CITY OF PORTLAND, MAINE

Project Name:	0 Hancock Street (Wex)	Project ID:	2017-180
Address:	0 Hancock Street	CBL:	019 A0014
Applicant:	0 Hancock Street, LLC, Jonathan Cohen		
Planner:	Caitlin Cameron

Subject: B-6 Eastern Waterfront Design Review – 0 Hancock Street

To: Caitlin Cameron - Planner
From: Keith Gray, PE – Senior Engineer, DPW
Date: September 25, 2017
Re: 0 Hancock Street (2017-180) – Level III Site Plan Application

Client/Project	0 HANCOCK LLC
THAMES STREET SITE	PORTLAND, MAINE
Title	GRADING, DRAINAGE AND EROSION CONTROL PLAN
Project No.	195350450
Scale	1" = 20'
Sheet	C-4.0

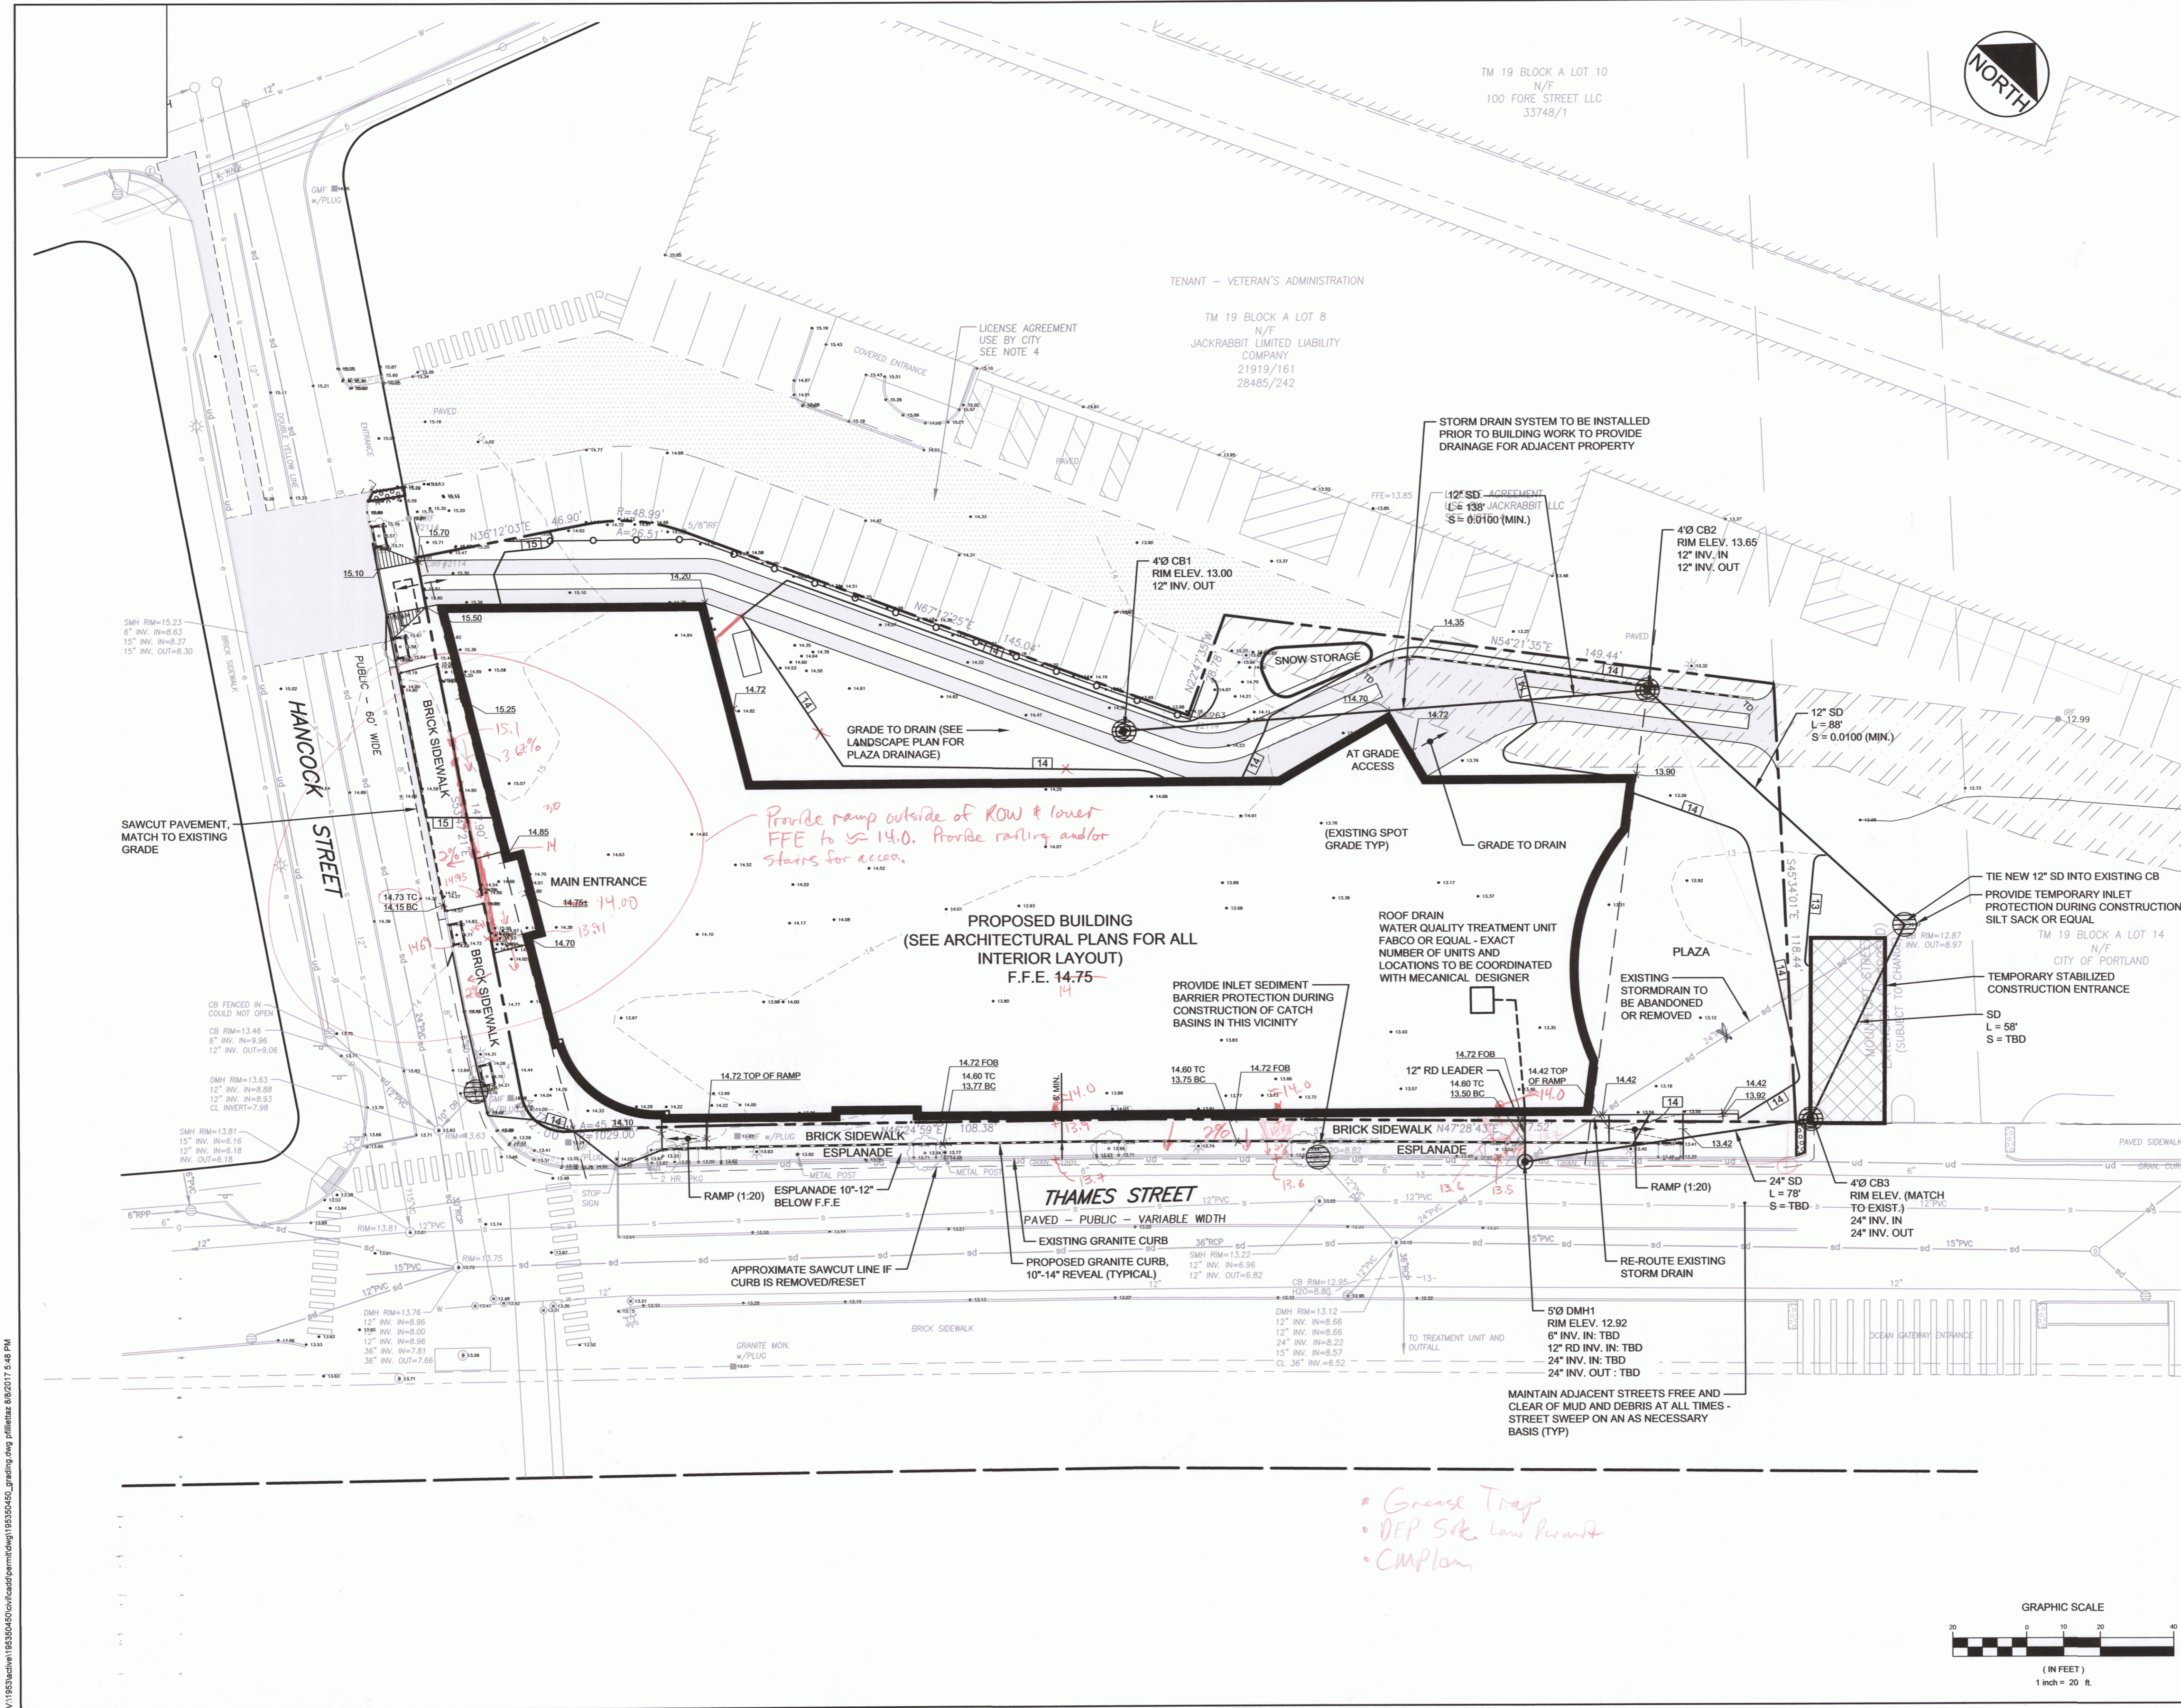
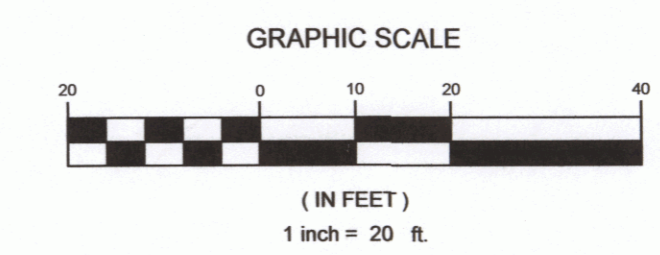
C-4.0 – Grading, Drainage and Erosion Control Plan:

- The applicant is proposing a grade break (vertical curb) within the Thames Street sidewalk to accommodate ADA building access.
 - DPW does not support a split grade sidewalk within the ROW
 - We suggest lowering the finish floor elevation by ramping down the sidewalk, within the applicant's property, at the Hancock Street entrance. The lowered finish floor elevation allows for a continuous sidewalk along Thames Street. See enclosed figure (For illustration purposes only, grades and design to be completed by Stantec).

Provide ramp outside of ROW & lower FFE to ≈ 14.0 . Provide railing and/or stairs for access.
